Emergency Preparedness Task Force

Passenger Safety Working Group

June 26, 2007

Notice of Proposed Rulemaking

Debriefing and Critique

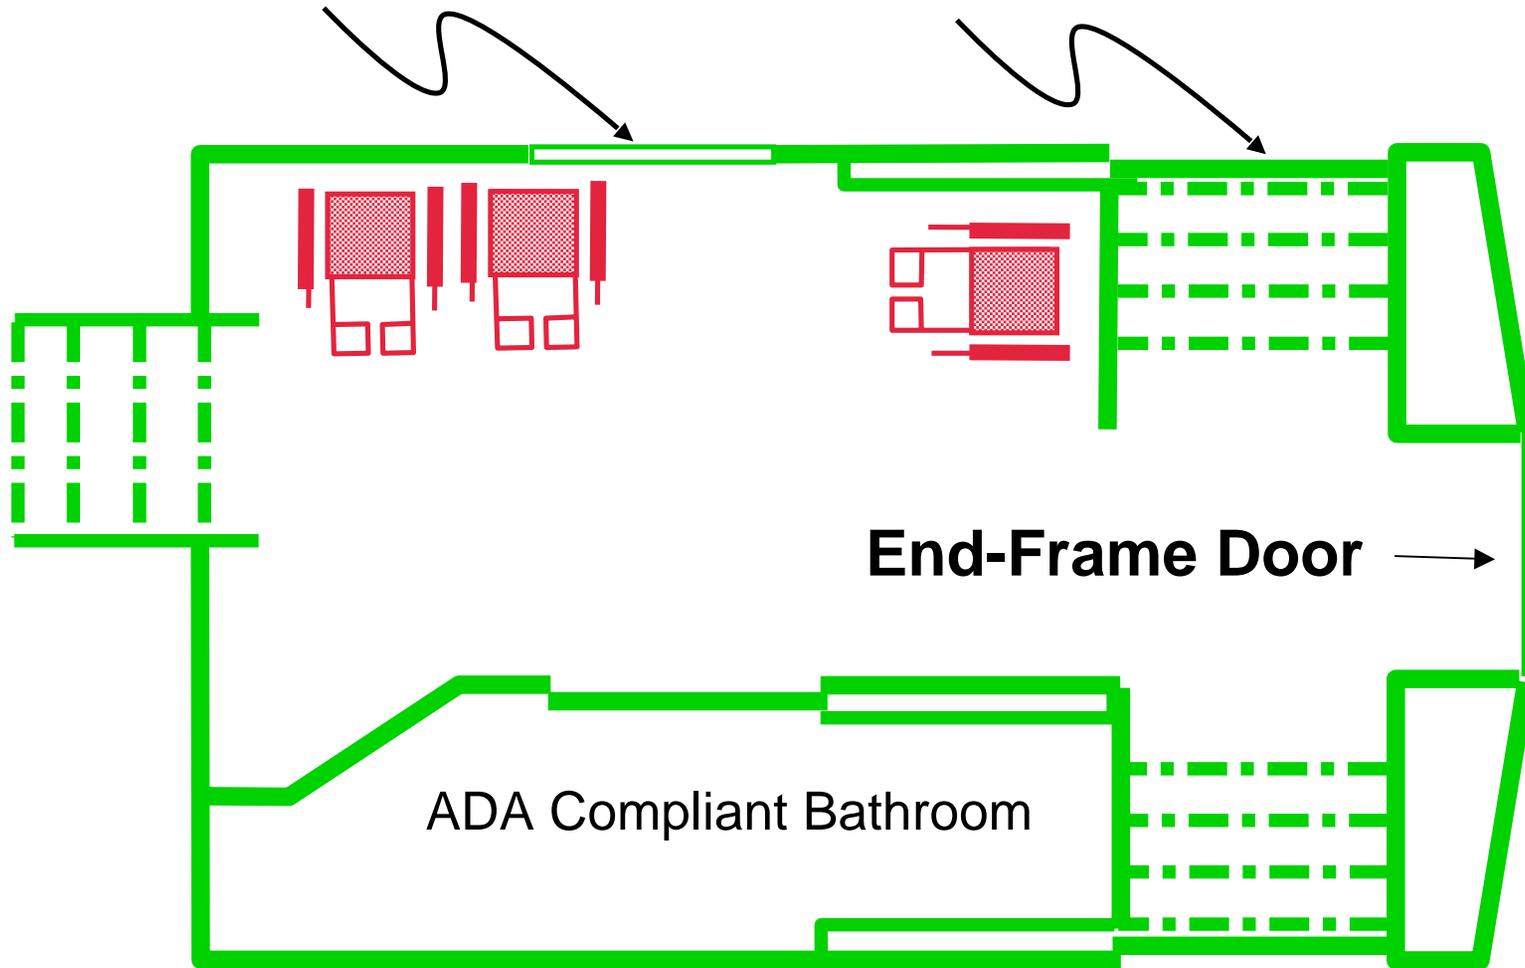
- Consider revising § 239.105 *Debriefing and critique* to clarify that train crewmembers should participate in the debrief and critique session held following a train emergency situation or a full-scale simulation

- **§ 239.105 Debriefing and critique.**

(a) *General.* Except as provided in paragraph (b) of this section, each railroad operating passenger train service shall conduct a debriefing and critique session after each passenger train emergency situation or full-scale simulation to determine the effectiveness of its emergency preparedness plan, and shall improve or amend its plan, or both, as appropriate, in accordance with the information developed. The debriefing and critique session shall be conducted within 60 days of the date of the passenger train emergency situation or full-scale simulation. ***To the extent practicable, all on-board personnel, control center personnel, and any other employees involved in the emergency situation or full-scale simulation shall participate in the session either in person or offsite via teleconference.***

Rescue Access and Emergency
Egress Window

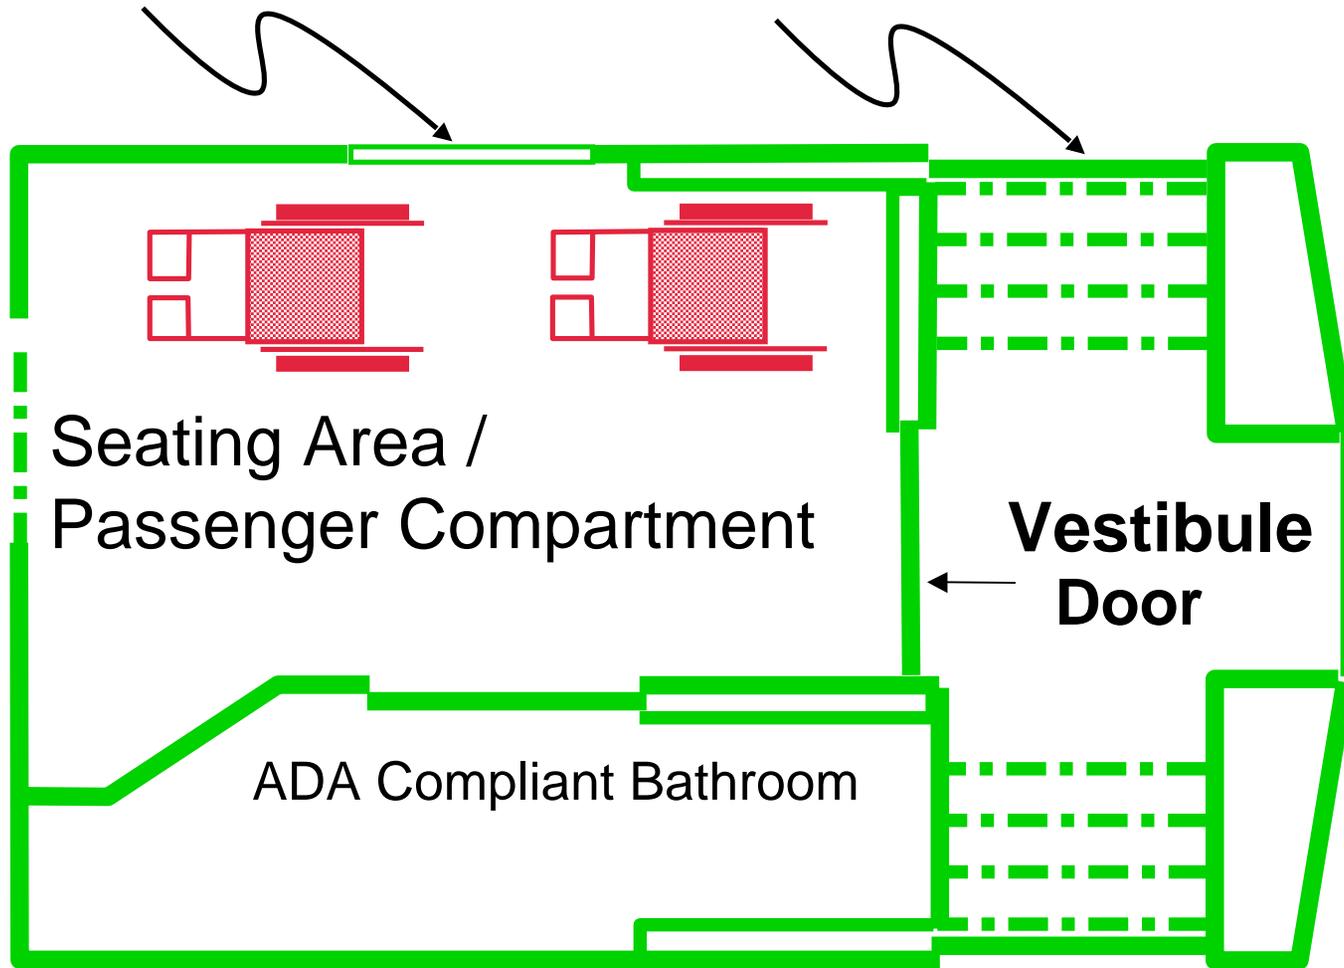
- ***Except as*** provided in paragraph (e)(4) of this section, each end-frame door located in an area of a passenger car separated from any side door exit by another level of the car shall be equipped with a removable panel or removable window for egress in the event the door will not open, or the car is on its side and the door is difficult to open. ***The requirements of this paragraph (e) do not apply to an end-frame door in an end of a passenger car where a control stand is located.***
